**Alex Avenue Public School – State Significant Development – Application Number SSD\_9368 (“SSD\_9368”)**

We refer to the modification application (being modification no. 4) pursuant section 4.55(1A) of the *Environmental Planning and Assessment Act 1979* (NSW) (“**EP&A Act**”) being sought by the Department of Education (“**DoE**”) to modify SSD\_9368 in relation to the Alex Avenue / Galungara Public School (“**MOD 4**”).

We are instructed to raise a formal objection and make submissions in relation to MOD 4 on behalf of our client the particulars of which are set out below.

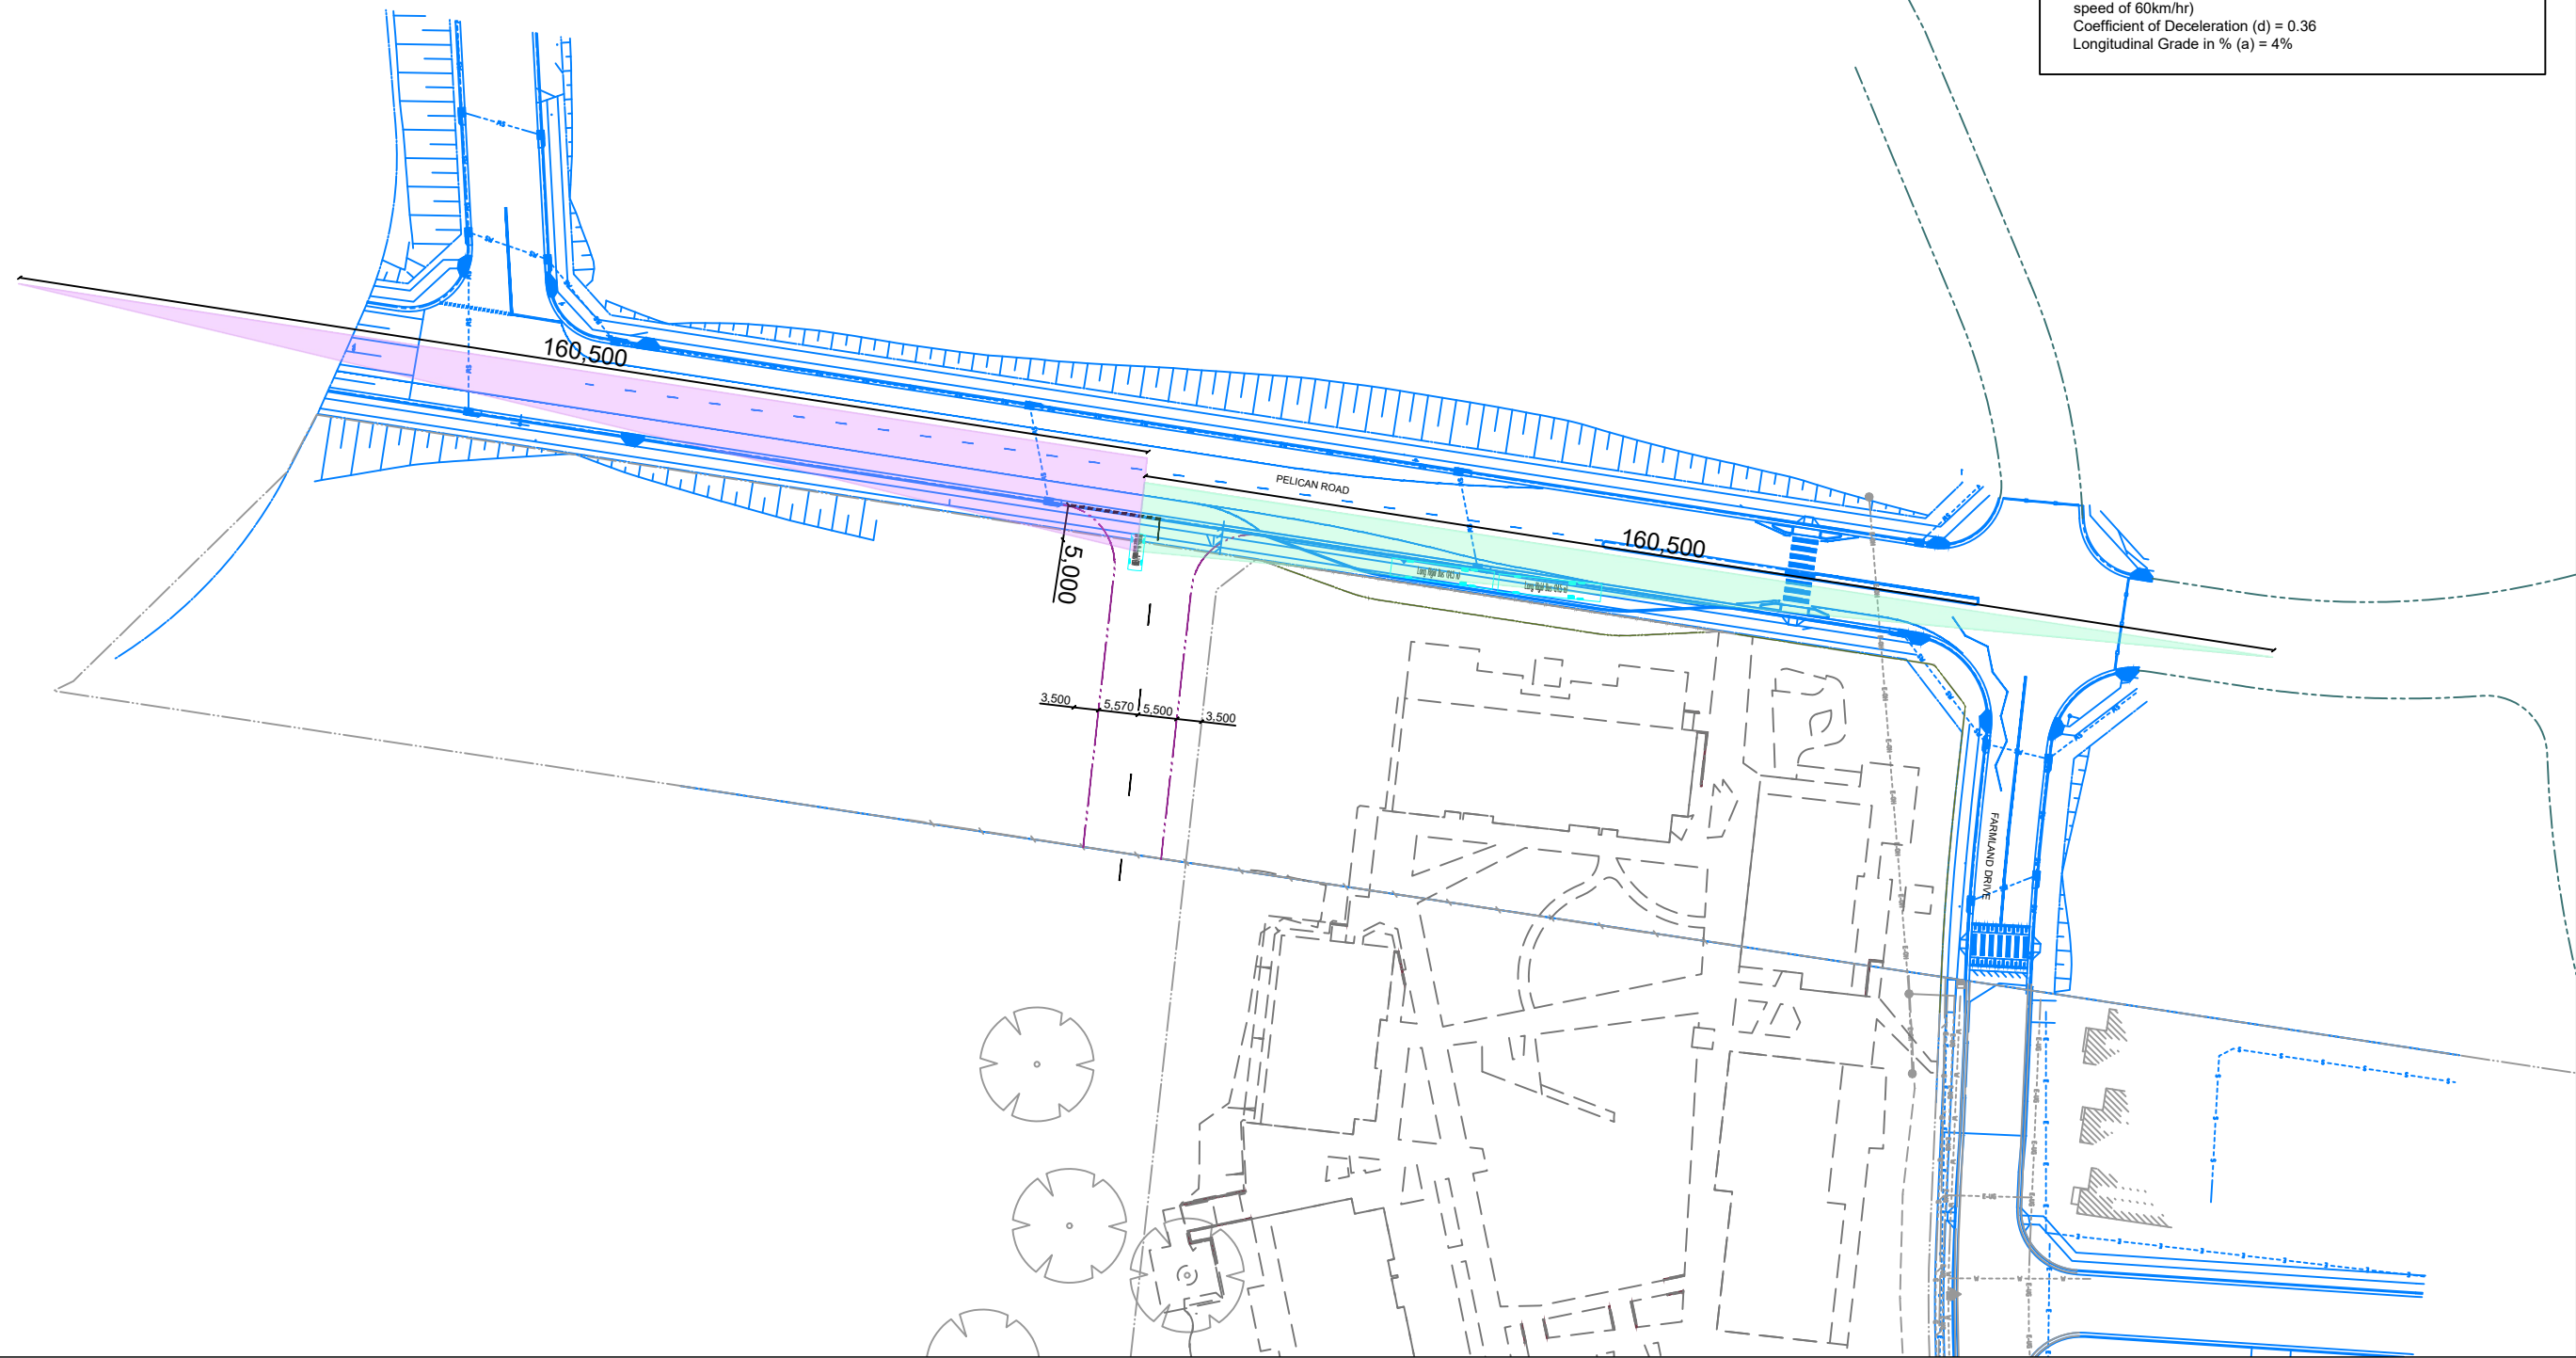
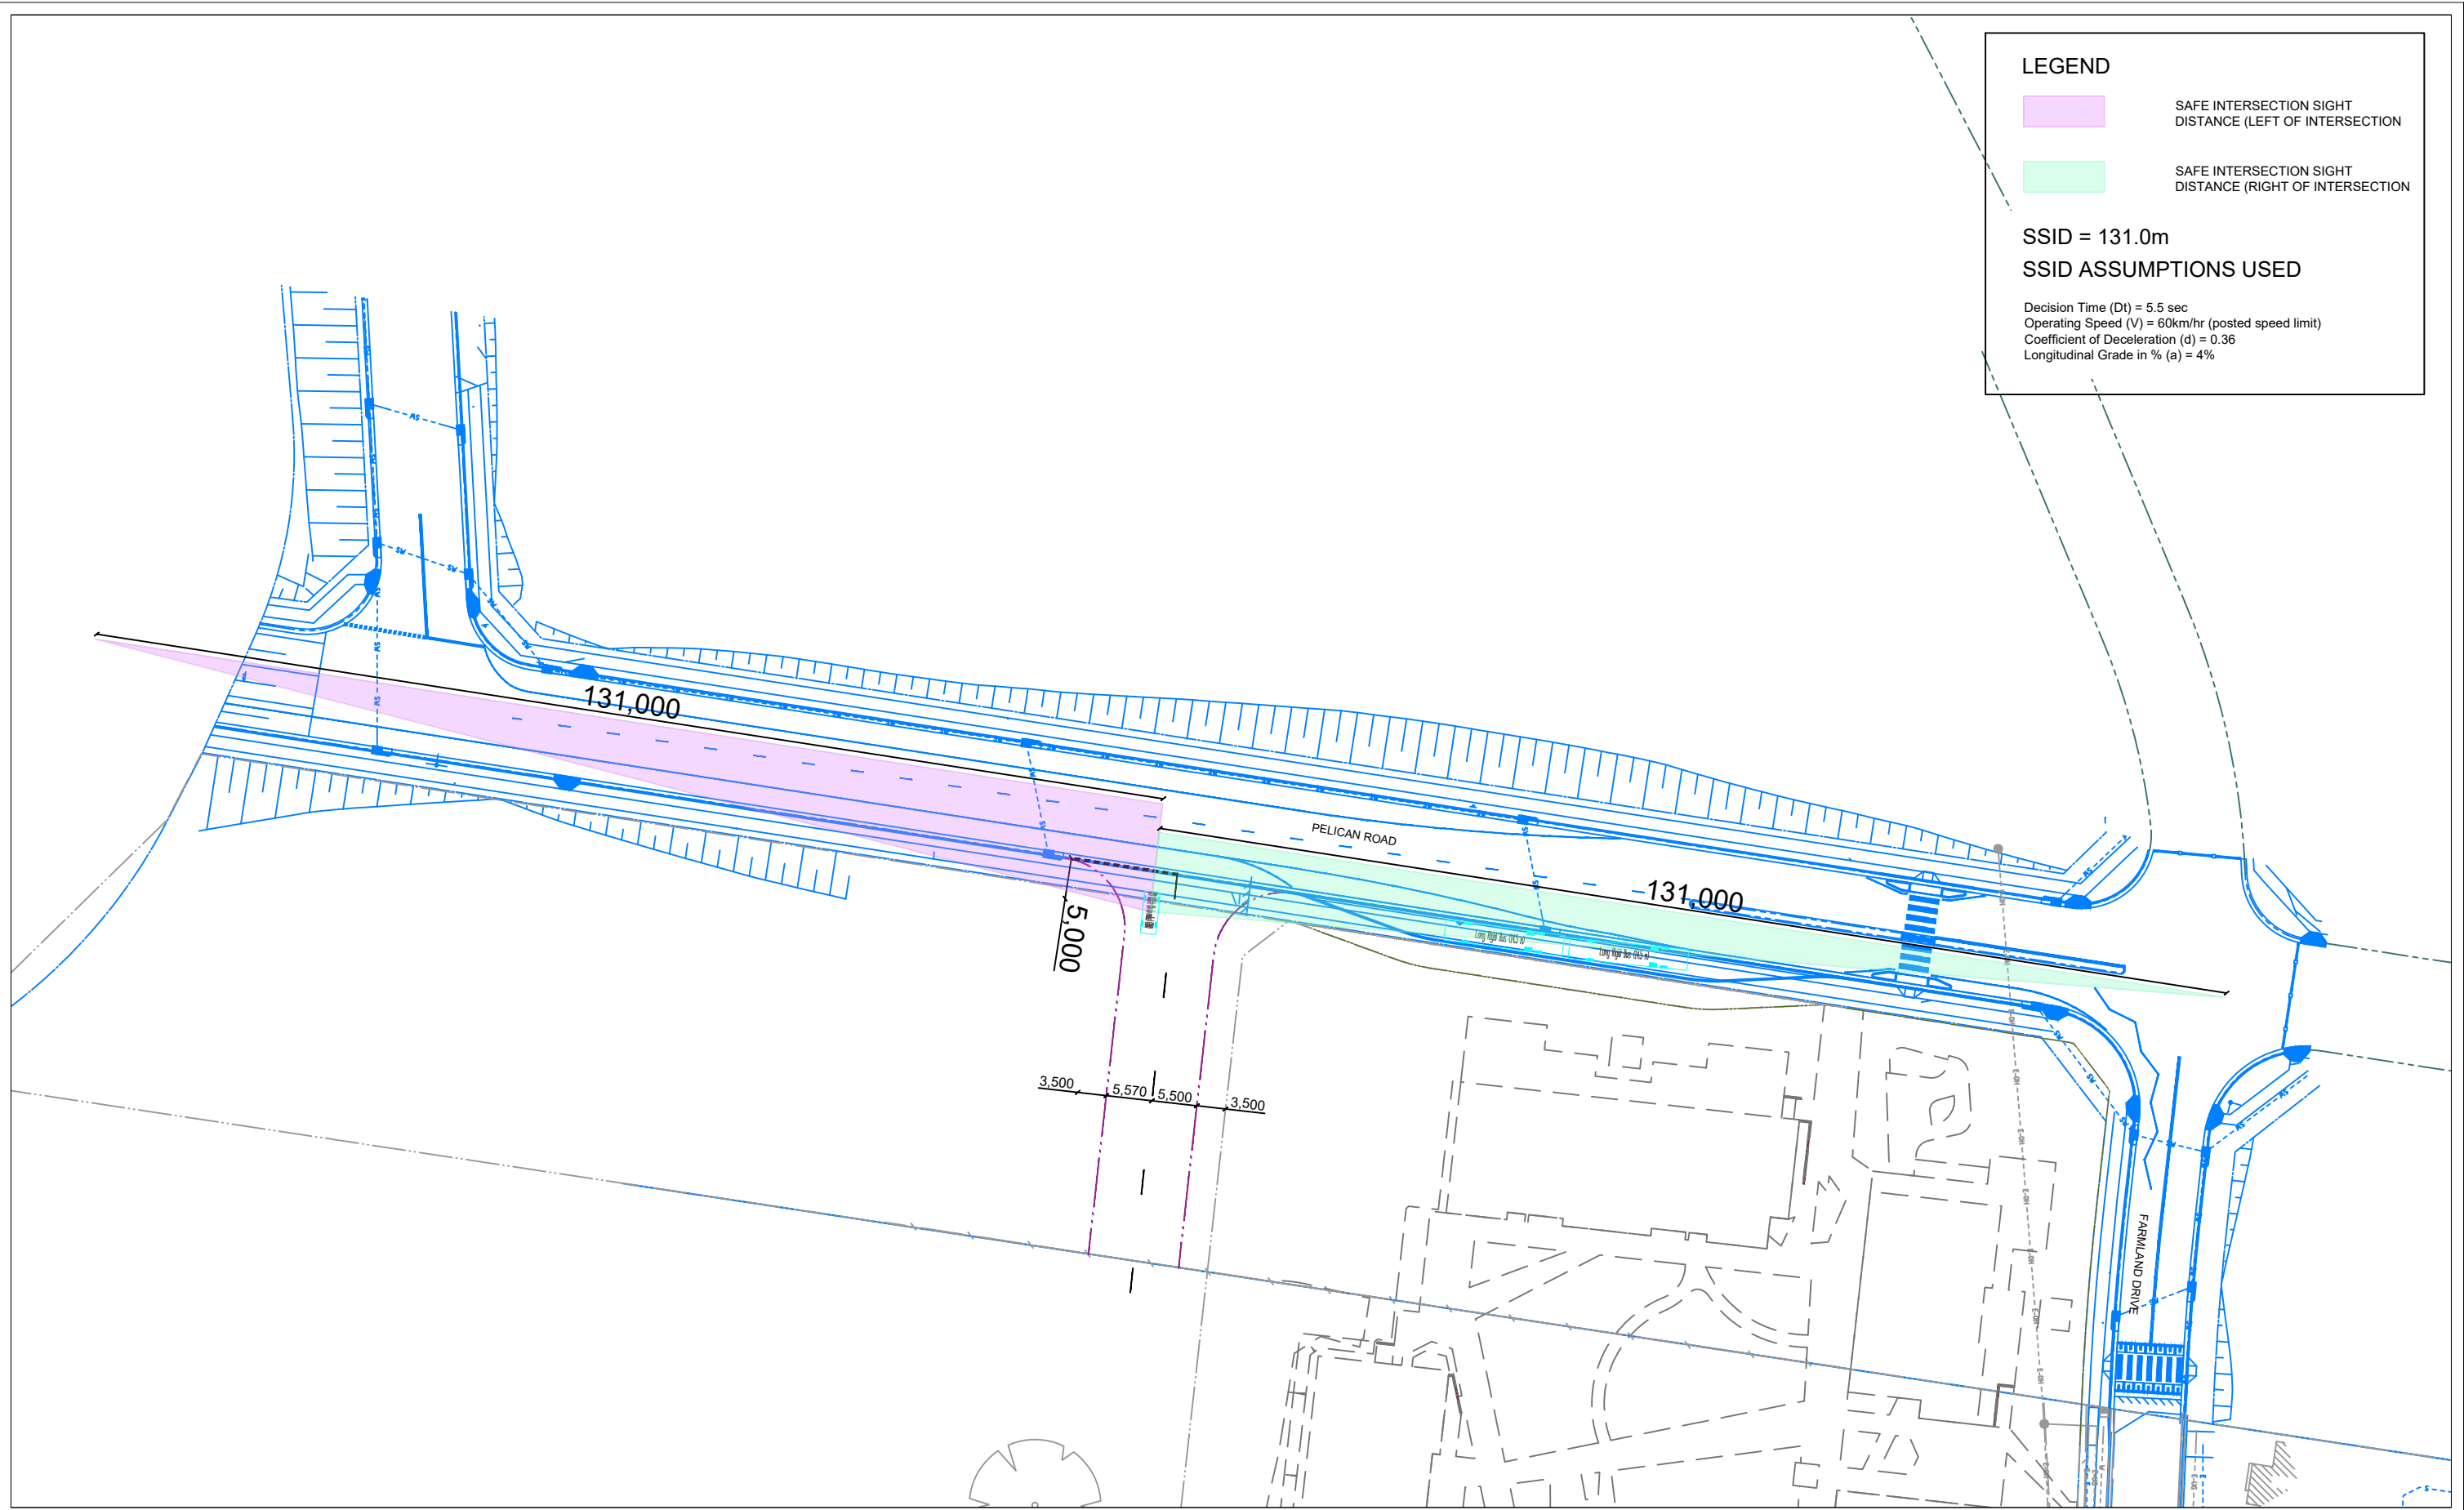
*"The outcome of that sightline assessment was provided on Sheet 02 of 10 attached to the GTA letter and is reproduced in the following pages, revealing that the sightlines required to achieve safe intersection sight distance in accordance with Austroads was 160.5m. Significantly however, **the GTA sightline assessment did not take into account the proposed bus bay which is illustrated on Sheet 03 of 10 in the GTA letter (also reproduced in the following pages) which has now been approved under SSD 9368.**"*

*If analysis exists which shows a sightline assessment that does take into account the proposed bus bay, please provide us with a copy of that analysis. If such analysis does not exist, please confirm this is the case.*

A revised SISD assessment has been completed based on approved Northrop Civil Design Drawings (which incorporates the approved Toplace road construction drawings) based on three scenarios:

As identified previously in GTA's assessment, the indented bus bay are for school bus use only. Further consultation undertaken with the local bus operator and TfNSW further confirmed that if a school bus is to be introduced, the school bus will only access the bus bay during the AM drop off and PM pick up period as part of a modified, linked public transport route. Buses are typically not expected to dwell within the indented bus bays for extended periods of time.
